The Commission has issued the enclosed Amendment No. 86 to Facility Operating License No. DPR-51 for Arkansas Nuclear One, Unit No. 1 (ANO-1). This amendment consists of changes to the Technical Specifications (TSs) in response to your application dated August 13, 1984.

AMENDMENT TO FACILITY OPERATING LICENSE

Amendment No. 86
License No. DPR-51

SUPPORTING AMENDMENT NO. 86 TO FACILITY OPERATING LICENSE NO. DPR-51

FIGURE 4.18.1

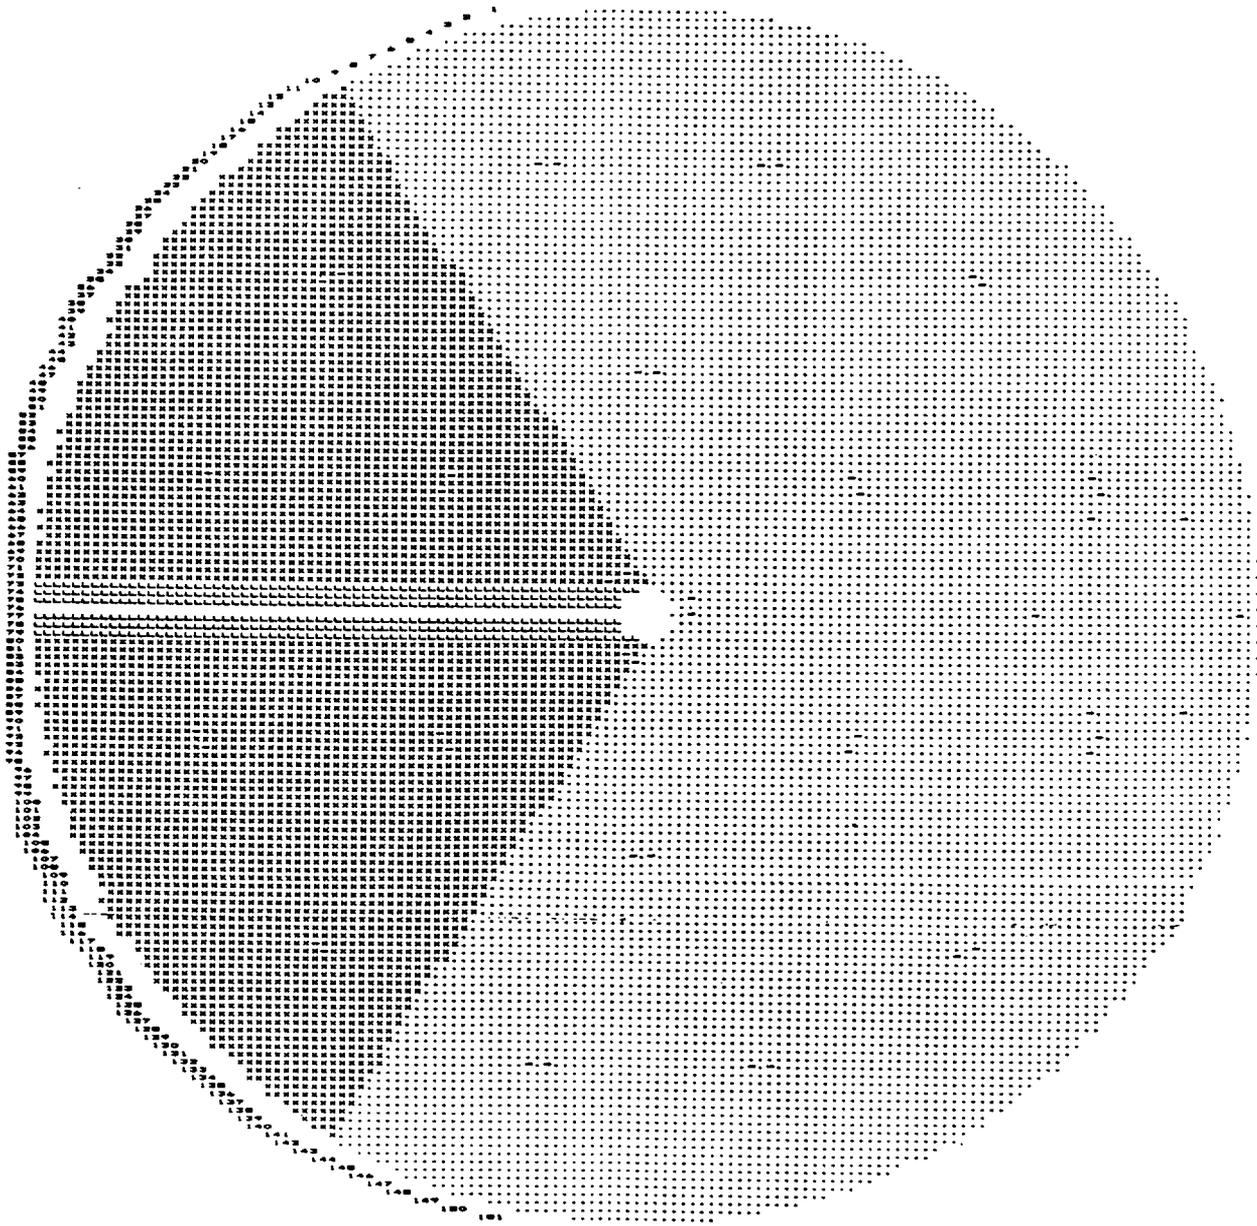
(3) Group A-3: Tubes in the wedge-shaped group on either side of the lane region (Group A-1) as defined by Figure 4.18.1.

In another change request, new special group A-3 is added. The new special group consists of 4,831 tubes adjacent to the lane region. The new group is a large wedge (1/3 of the tube bundle) originating at the center of the bundle fanning out on either side of the lane region. This new special group is selected due to tube degradation noted in recent steam generator tubing inservice inspections and recent leaker outage tube inspections. Sample analyses performed on tubes pulled during recent inspections have shown that IGA is the root cause of tube degradation leading to the plugging of approximately 280 tubes in the OTSGs. This attack has been concentrated in and around the lane region, group A-1, and at the periphery of the tube bundle near the lane. The proposed group A-3 more than adequately bounds the region of degraded tubing found to date.
